CNL-18-043

Clinch River Nuclear Site  
NRC Docket No. 52-047

Subject: Submittal of Revised Site Safety Analysis Report Subsection 2.4.3.2, "Probable Maximum Precipitation," in Support of Early Site Permit Application for Clinch River Nuclear Site

Clinch River Nuclear Site Safety Analysis Report Revised Subsection 2.4.3.2 and Figure 2.4.3-2

Figure 2.4.3-2. Rainfall Time Distribution – Typical Mass Curve

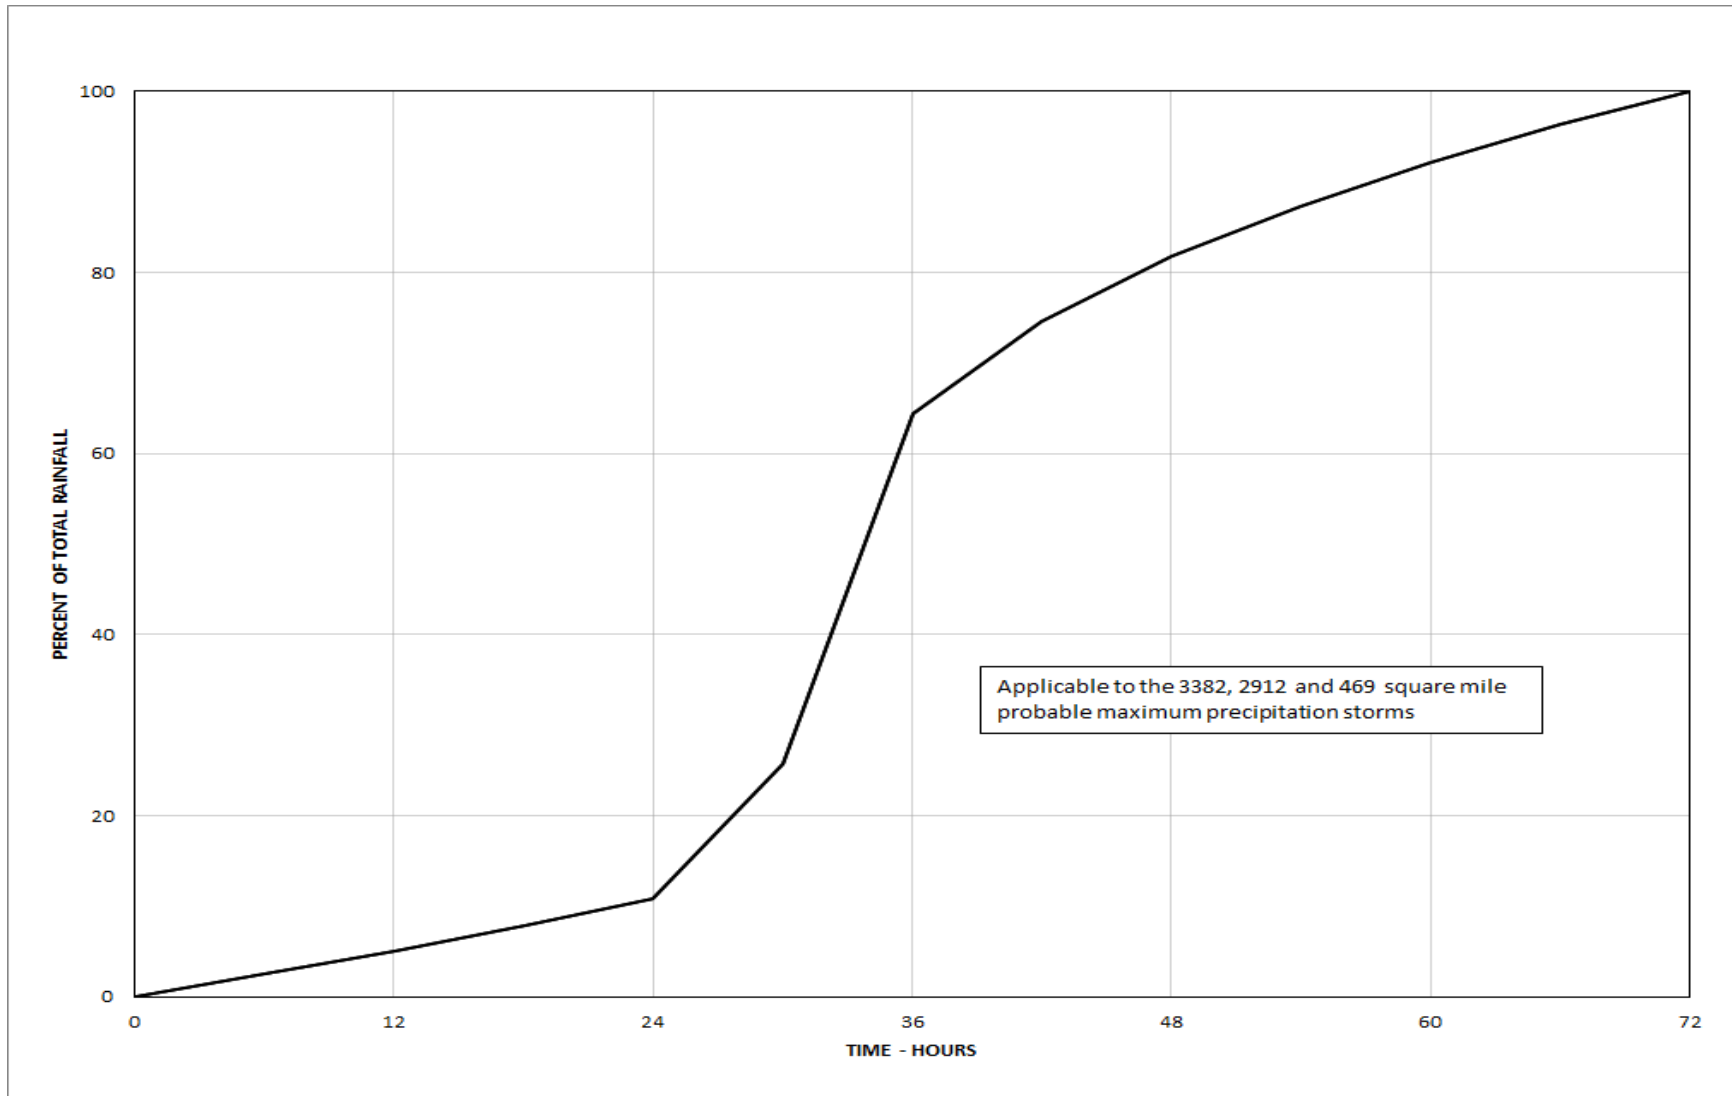
SSAR Figure 2.4.3-2 is being revised (inserted applicable PMP storms box) and will be replaced with the following figure.
